IEEE802.3af DTE Power via MDI task Force.

Annex to my comments for draft 3.1 with updates for draft 3.1 drawings according to July/2002 meeting during the comment resolution process.

Rev 002

July 11, 2002

Figure 33-12

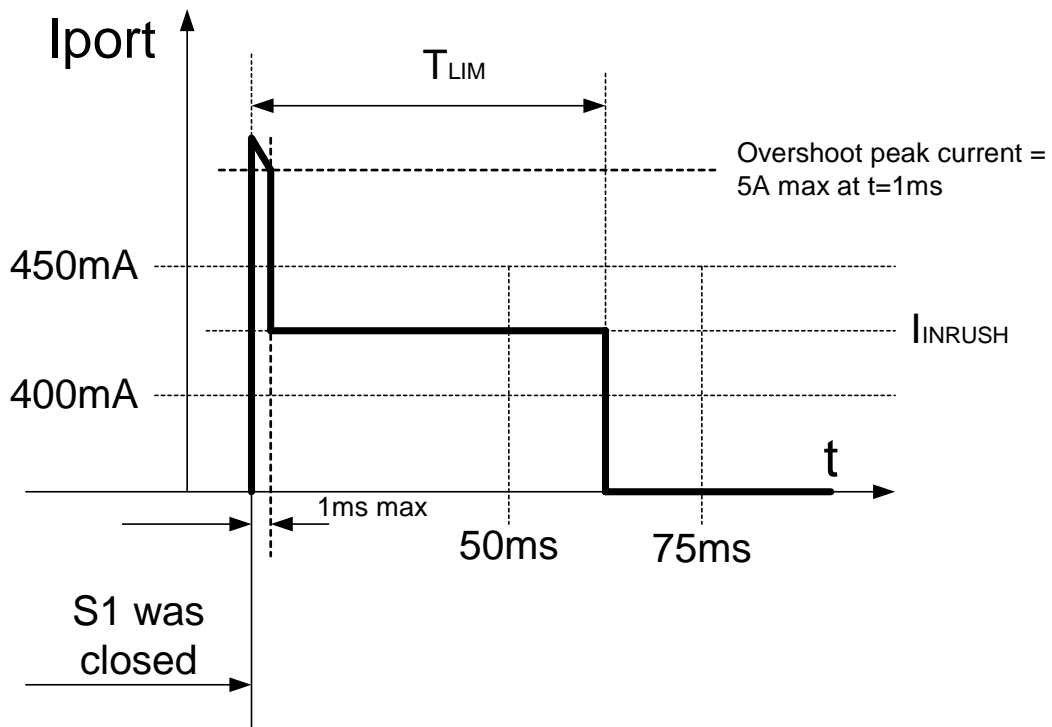
(Comments (T/TR) 415, 335, 166, 167) (Applies to figures 33-12 and 33-16)

Figure 33-18

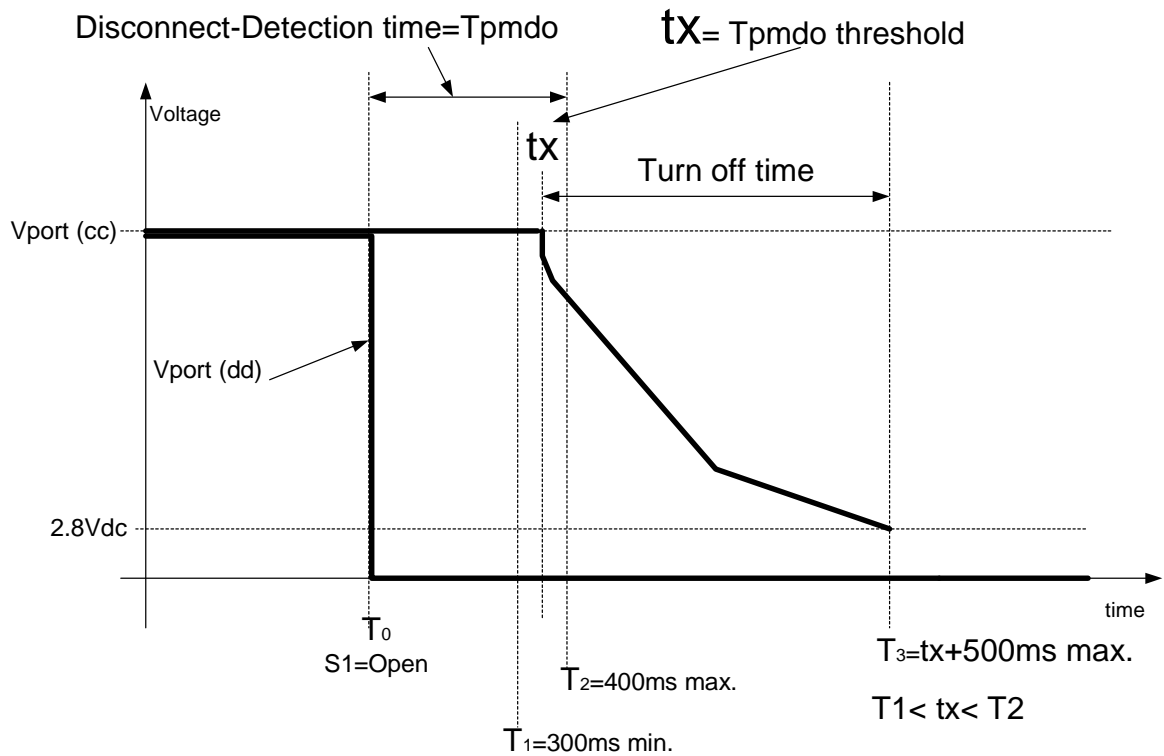
Change the following text :

Page 52, line 44: remove the words starting with “by verifying...” to the end of this sentence at line 45.

Page 53, line 16,17: delete “(Power is removed when....5mA)”

Page 63, line 2: delete line 2 “power is removed when ...1Vmin”

Figure 33-21

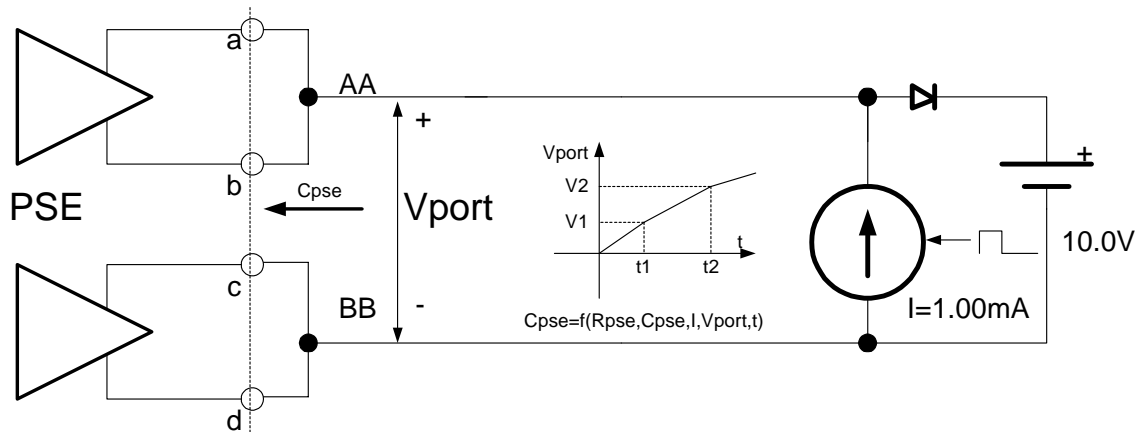
Replace step 1 in page 60 line 35 with:

Delete step 2, page 60 line 39.

1. Set PSE port to OFF mode.
Connect switched current source, I to the PSE port.
The current source voltage shall be clamped to 10V.
Calculate Port capacitance (C_{pse}) by measuring R_{pse} (Port resistance) and using it in typical differential equation solution specified in figure 33-5-18.

Figure 33-22

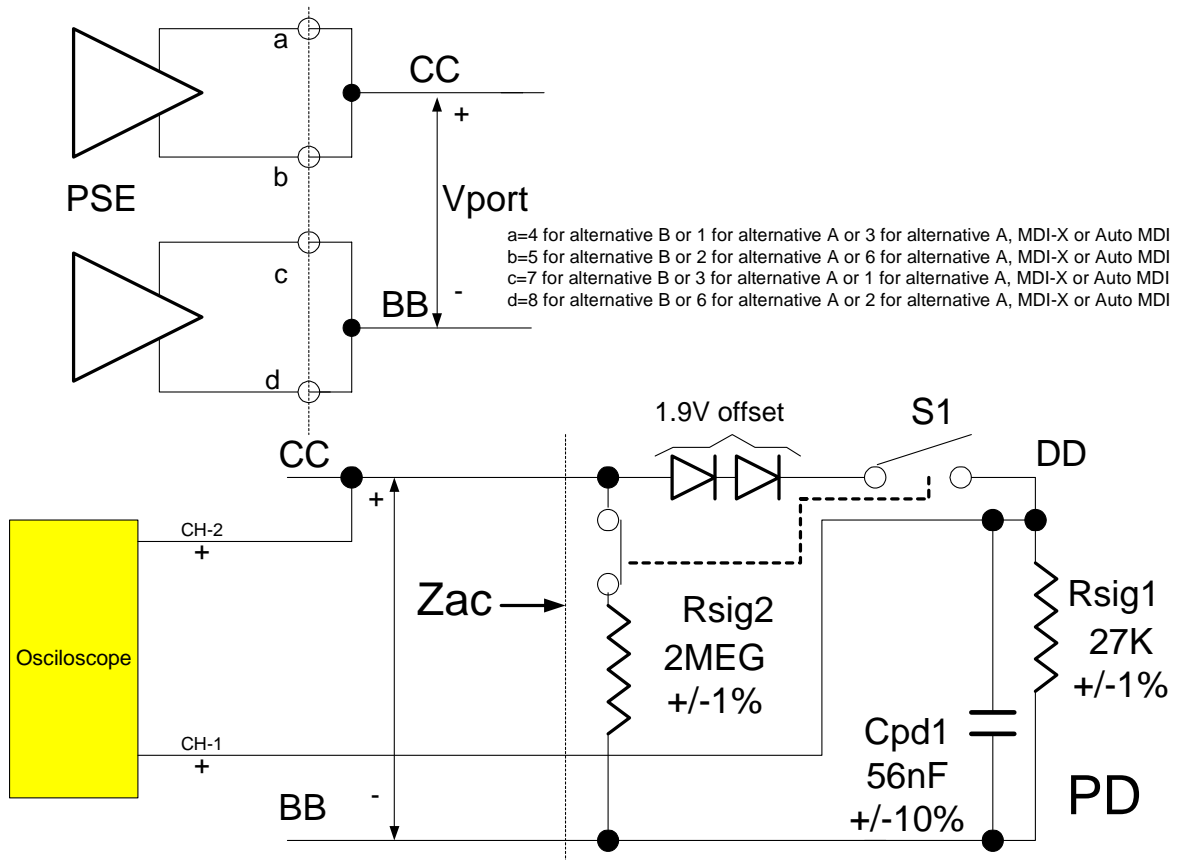
Replace step 1 in page 62 line 49 with:

“Set S1=close (Rsig1 connected to the port, Rsig2 not connected to the port).
 Measure V_{port} and verify that $44V \leq V_{port} \leq 57$ and $V_{close} < 0.5V_{pp}$ ”

Figure 33-23

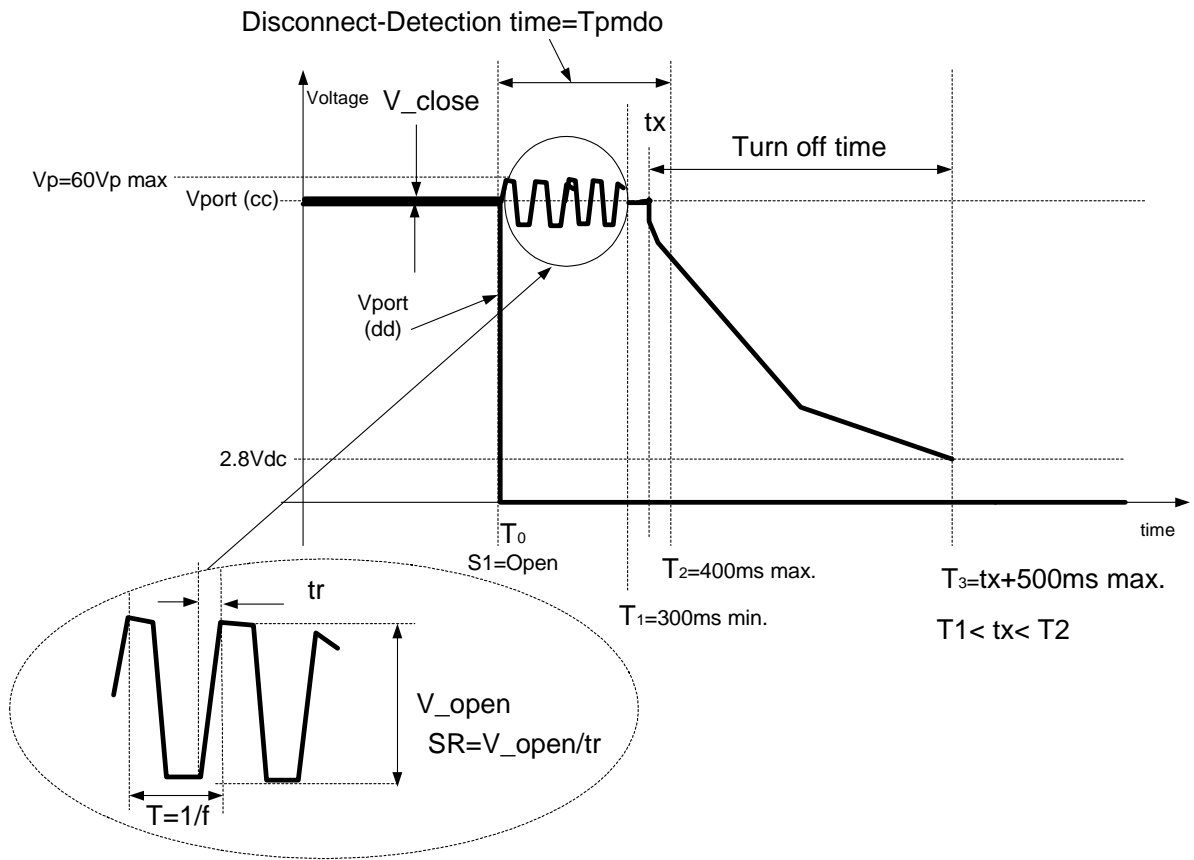
Delete line 2 page 63 "(power is removed...1V min)"
 Delete line 16,17 page 53 "(power is removed...5mA)"

Figure 33-28

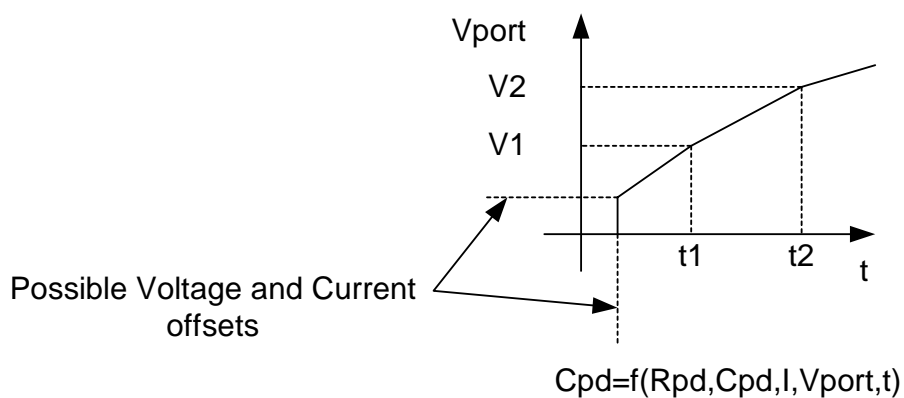
Replace step 9 in page 68 line 42 with:

Delete step 10, page 68 line 43.

1. Calculate Port capacitance (C_{pd}) by measuring R_{pd} (Port resistance) and using it in typical differential equation solution specified in figure 33-28.

Figure 33-29

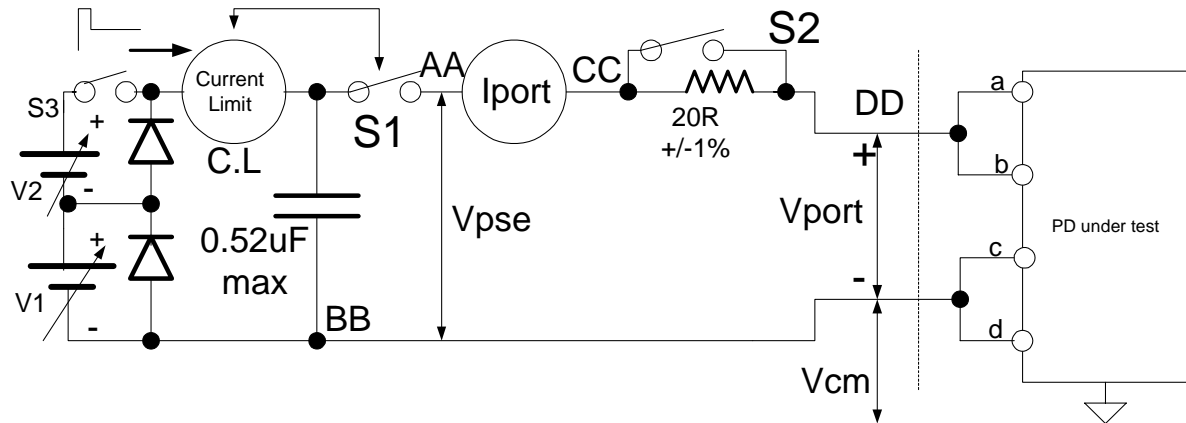
Add to page 75 line 34: (Refer to comment #53)

“25) Set V1 to 44V, V2=0V, Set S1 to ON. Measure Vport and Vcm noise level at Vport 37V to 57V and at all known PD operating load conditions.”

Figure TBD1 – Z_{ac1} definition as indicated in table 33-6.
 R_{pd_d} , C_{pd_d} specified in table 33-14.

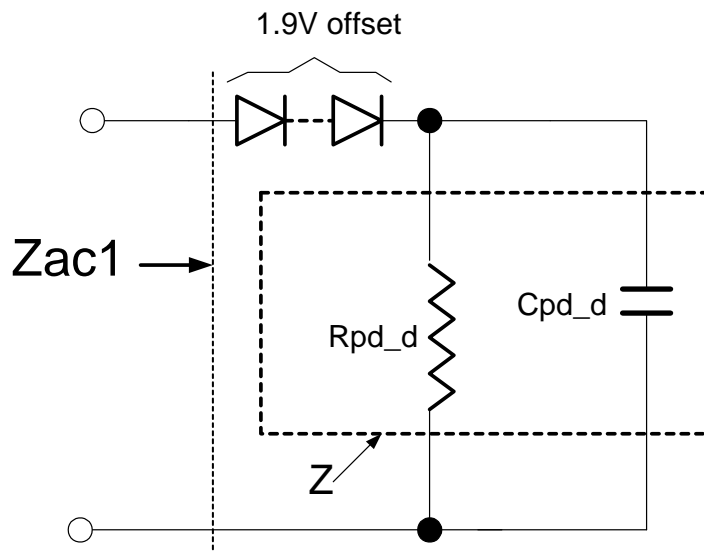
Add the following figures TBD1 and TB2 after table 33-6.

Figure TBD1 for PSE-PD system impedance allocation

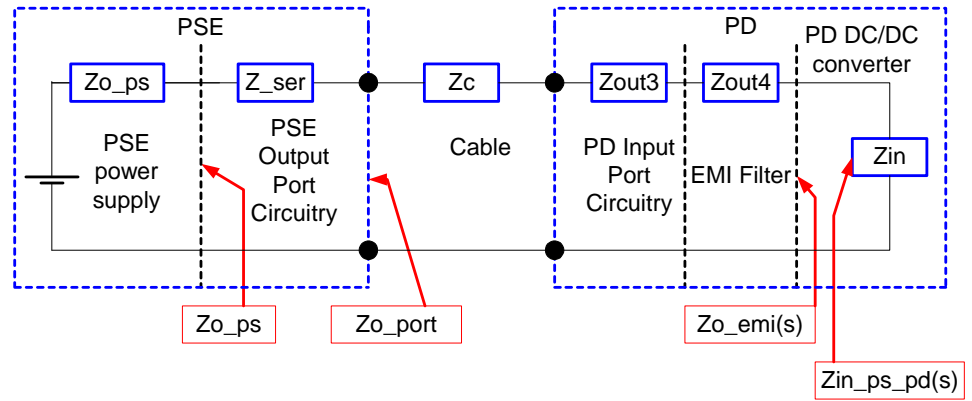
Drawings for my comments regarding 33.2.9 page 46 line 34 and 33.3.5 page 73 line 33
